PIC10F220/222 Rev. A Silicon Errata

The PIC10F220/222 parts you have received conform functionally to the Device Data Sheet (DS41270B), except for the anomalies described below.

FIGURE 1: TYPICAL DNL AT 2.0V (TESTING AT 7-BIT LEVEL)

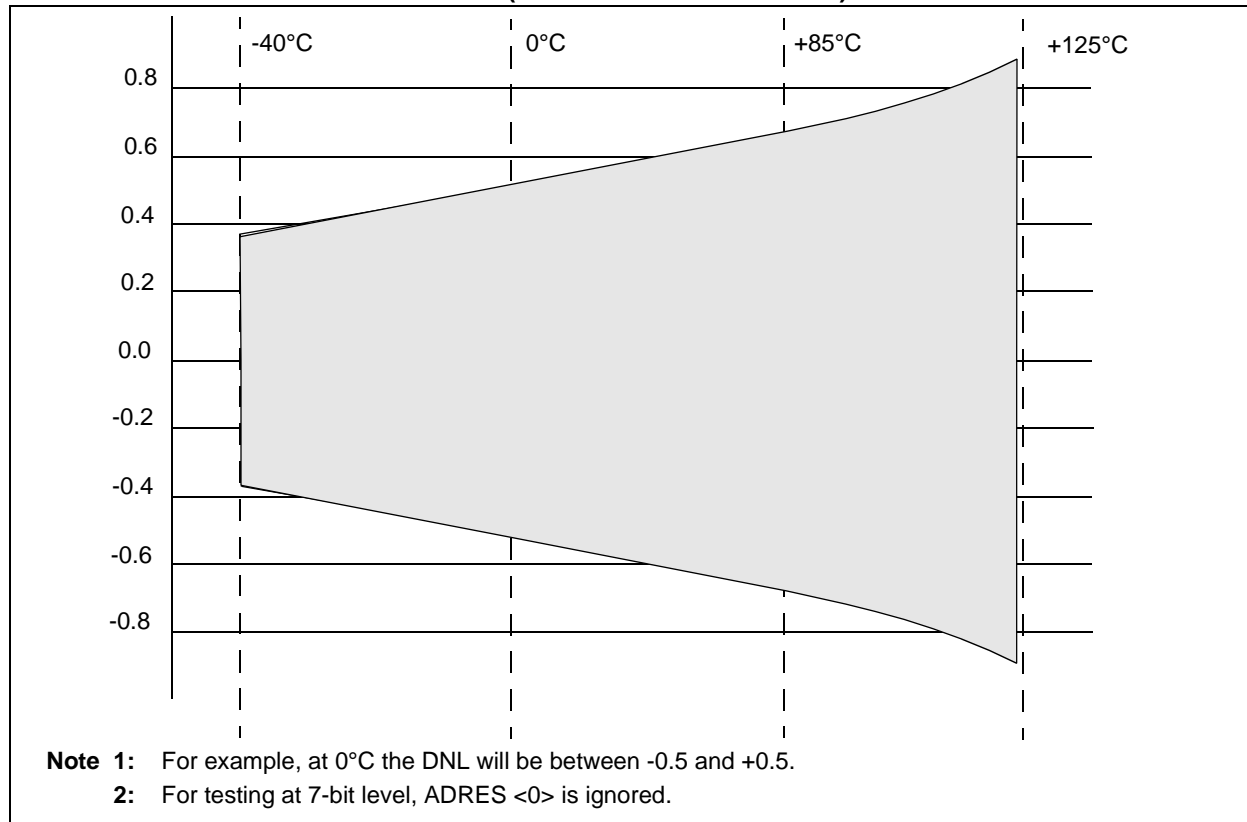
PIC10F220/222 silicon Rev. A1. The A/D Converter does not meet the design target. The specifications listed below in Table 10-6 supersede Table 10-6 in DS41270B.

Note 1: This will be addressed in future silicon revisions.

Work around:

None.
